# South Franklin Congregational Meeting House

## Existing Conditions Report and Peer Review

762 Washington Street,  
Franklin, MA 02038

September 30, 2020

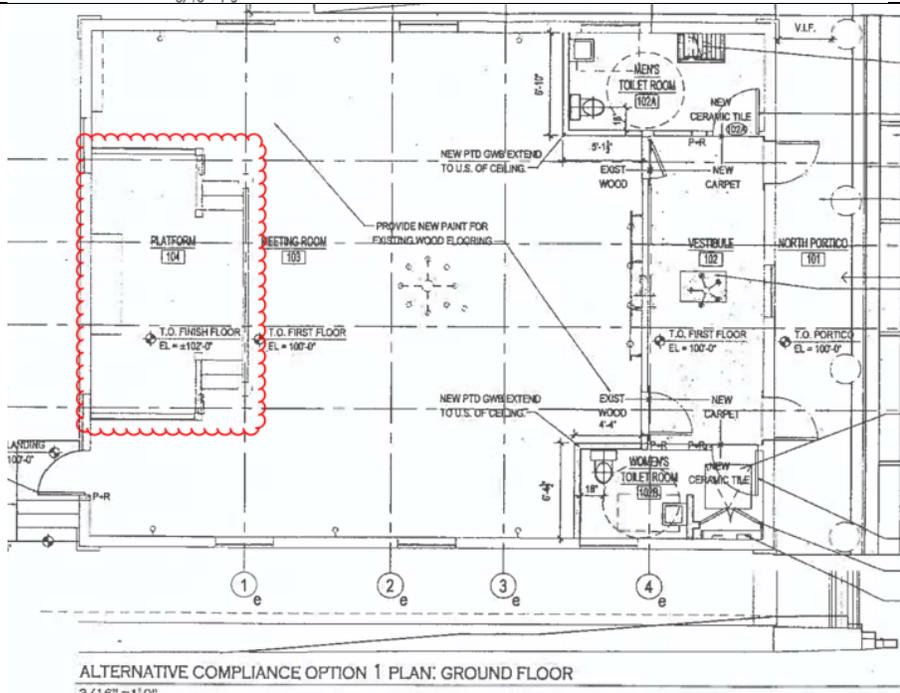
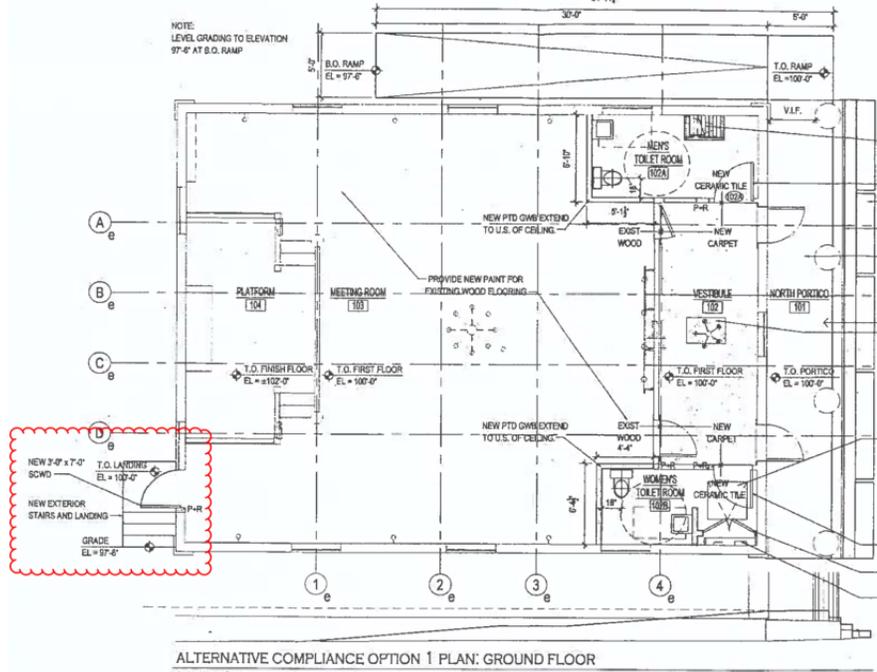
will continue to function as a place of  
specific requirements associated with the  
CMR Chapter 14.00 should be provided.  
threshold, then all public portions of the building

building are not required to be re-evaluated as  
are occurring.

compliance with Chapter 11 of the MEBC is an  
required *evaluation* method.

numbers for occupant load up to the nearest  
to add a level of conservatism. This applies to

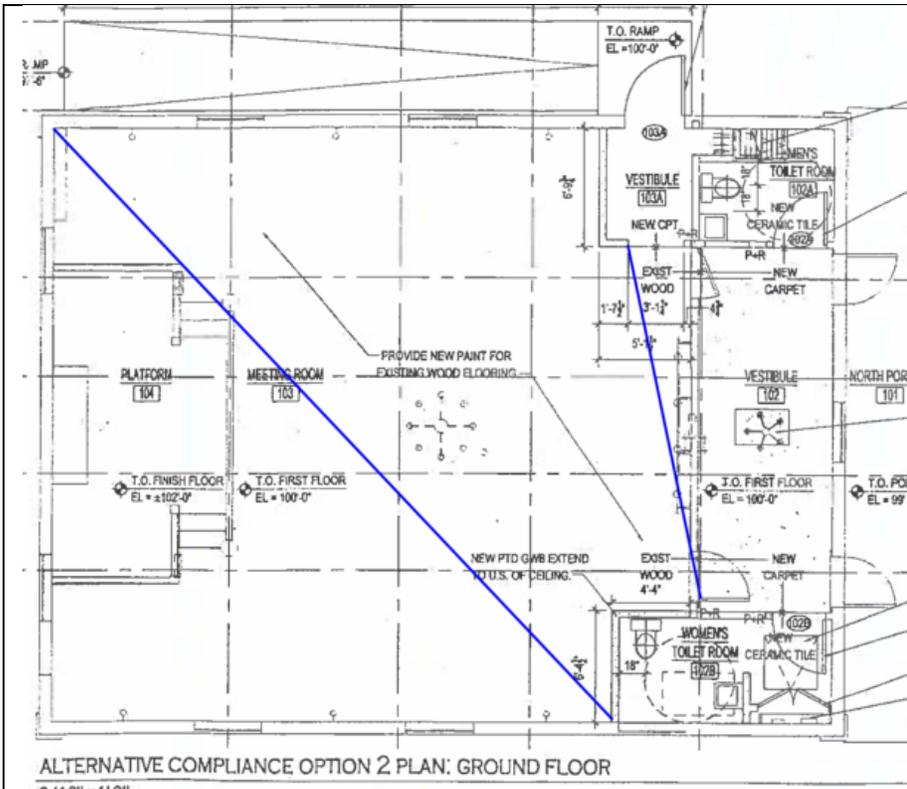
This floor plan shows the building layout and proposed accessible route. 780 CMR Section 1009.1 Except for existing buildings. However, 521 CMR requires accessible means of egress anywhere that more than one person has been in the past, the provisions of 780 CMR have been updated. However, recent experience is that for certain spaces on the ground floor that do not have an accessible means of egress is required.

An accessible route is required to be provided (see the options).

being provided with only one accessible means of egress. Section 1 omits accessible means of egress in 521 CMR Section 20.11.1.a requires two accessible means of egress if more than one means of egress is provided. In the final rule, the provisions of 521 CMR have been applied to the stage area. Therefore, another means of egress is required to be provided from the space.

the existing stage/altar space (both compliance

The existing egress points are not removed. The new egress path is along the diagonal of the floor. It is expected that the existing exit will be used.

ALTERNATIVE COMPLIANCE OPTION 1 PLAN: GROUND FLOOR

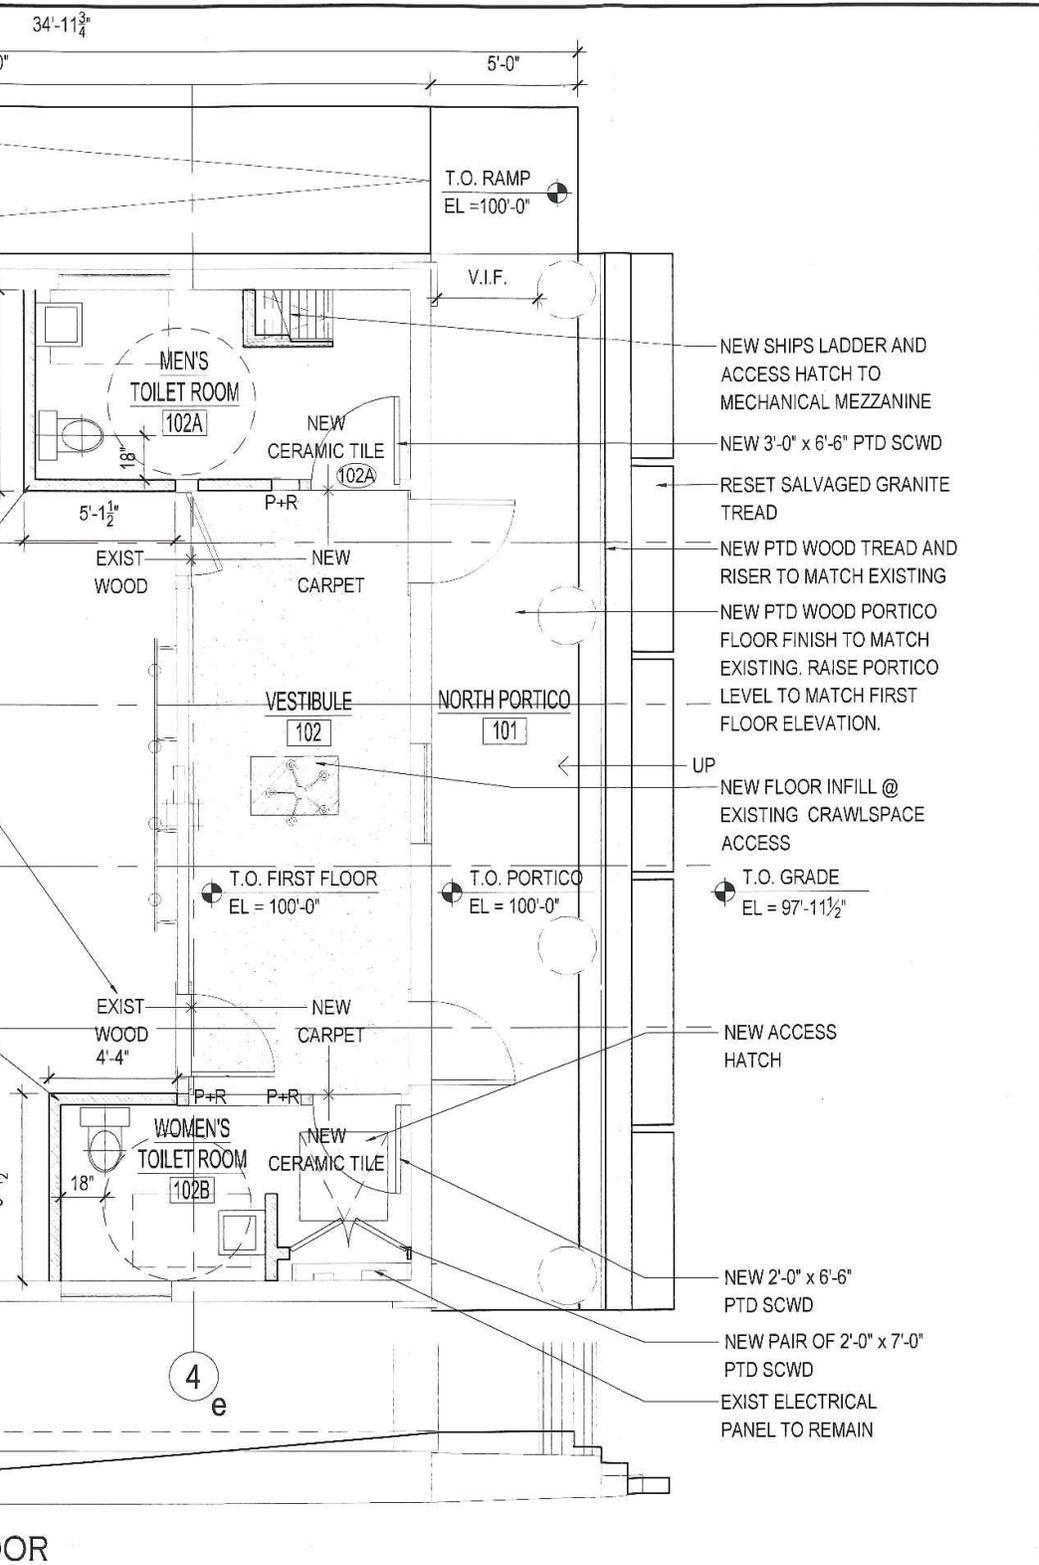
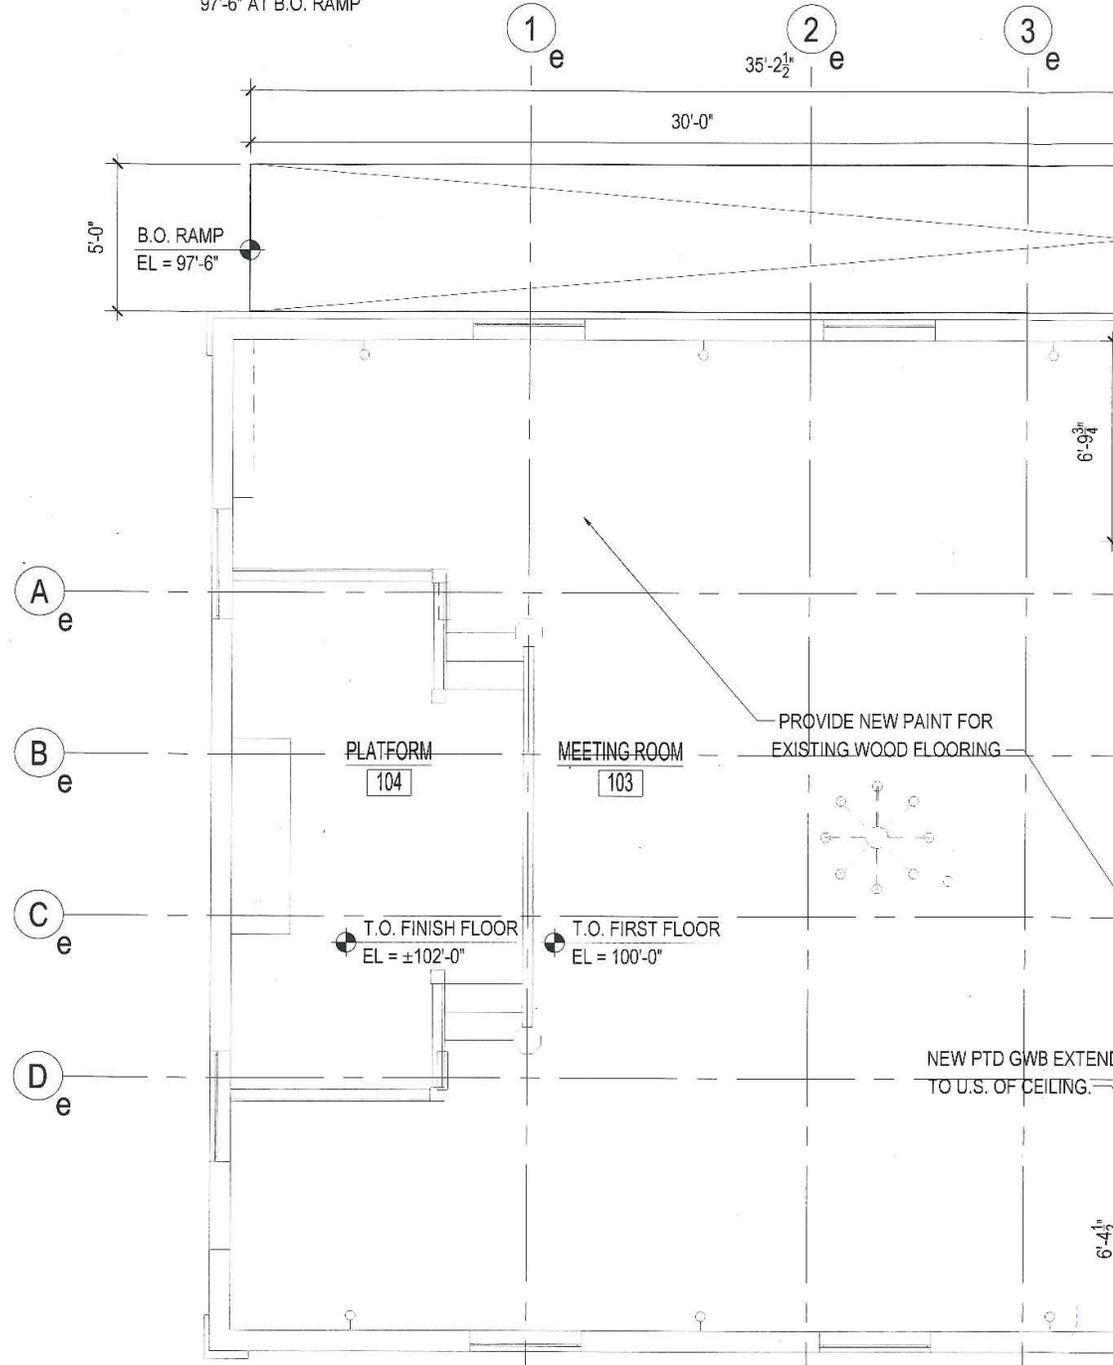
needed. Additionally, in order to address the existing 9-1/2" (+/-) differential between the portico level and the 1<sup>st</sup> floor, the portico level would need to be raised to meet the level of the 1<sup>st</sup> floor. Raising the portico level is **technically feasible**; the existing portico framing and stair can be modified to comply. However, raising the portico level and the inclusion of a ramp leading to the front portico would arguably detract from the façade's historic aesthetics (refer to drawing A1.1 – Alternative Compliance Option No. 1).

ALTERNATIVE COMPLIANCE OPTION 2 PLAN: GROUND FLOOR

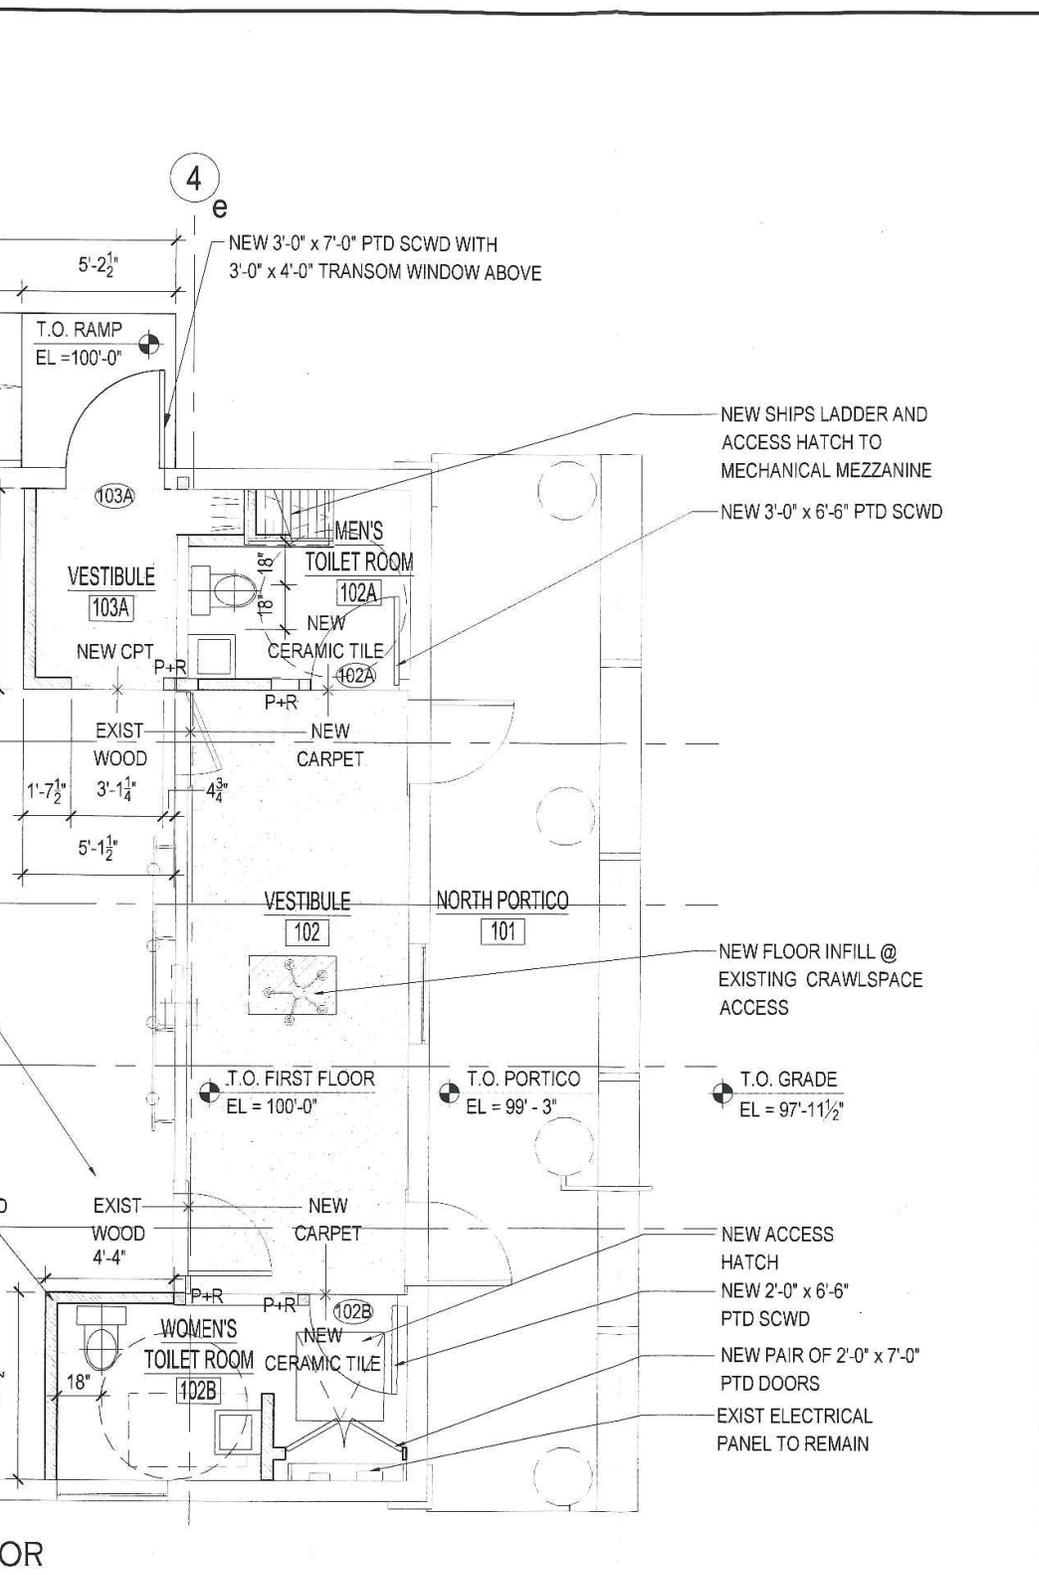
accessible. However, per Exception No. 1 of this section, if a main entrance cannot be made accessible, an accessible non public entrance that is unlocked while the building is occupied shall be provided. Exception No. 2 offers an alternative to making the main entrance accessible by providing a locked accessible entrance with a notification system or remote monitoring (refer to drawing A1.1 – Alternative Compliance Option No. 2).
